Project	IEEE 802.16 Broadband Wireless Access Working Group < http://ieee802.org/16 >	
Title	Renaming of handover and paging SAP primitives in section 14.5.9.2	
Date Submitted	2006-01-09	
Source(s)	Ronald Mao Huawei Technologies Co., Ltd. 10180 Telesis Ct #365 San Diego, CA 92121	Voice: 001-858-882-0335 Fax: 001-858-882-0350 rmao@huawei.com
Re:	Contribution on IEEE 802.16-2004/IEEE802.16g	
Abstract	This contribution proposes to update the primitive names in sections 14.5.9.2 of 16g r2.	
Purpose	Adoption	
Notice	This document has been prepared to assist IEEE 802.16. It is offered as a basis for discussion and is not binding on the contributing individual(s) or organization(s). The material in this document is subject to change in form and content after further study. The contributor(s) reserve(s) the right to add, amend or withdraw material contained herein.	
Release	The contributor grants a free, irrevocable license to the IEEE to incorporate material contained in this contribution, and any modifications thereof, in the creation of an IEEE Standards publication; to copyright in the IEEE's name any IEEE Standards publication even though it may include portions of this contribution;

[Figure 1](#) Paging Group Management Service Primitives

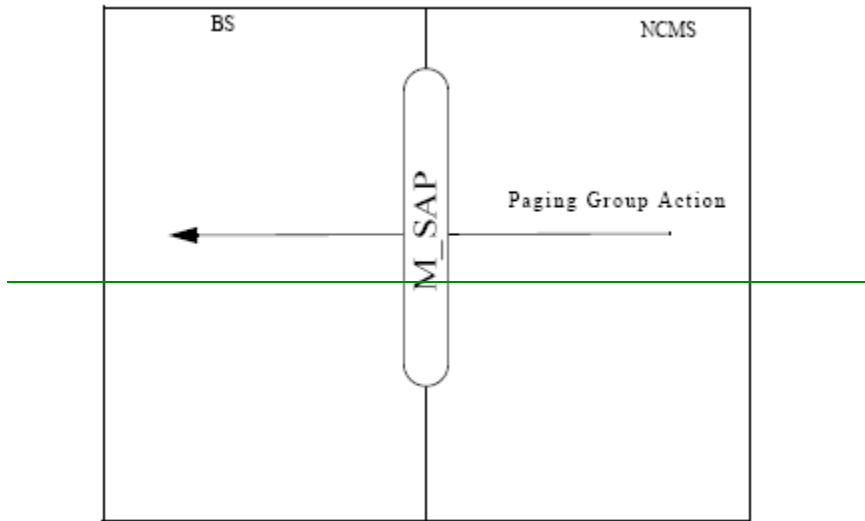
14.5.9.2.1.2.1 ~~Paging Group Action~~ M-PG-REQ

M-PG-REQ
Paging Group Action
(
  Operation type: Set,
  Action type: Paging Group Action,
  Object ID: NCMS,
  Attribute List:
  Paging Controller IDs
  Number of Paging Group IDss
  P a g i n g           G r o u p           I D           L i s t
)
Paging Controller ID
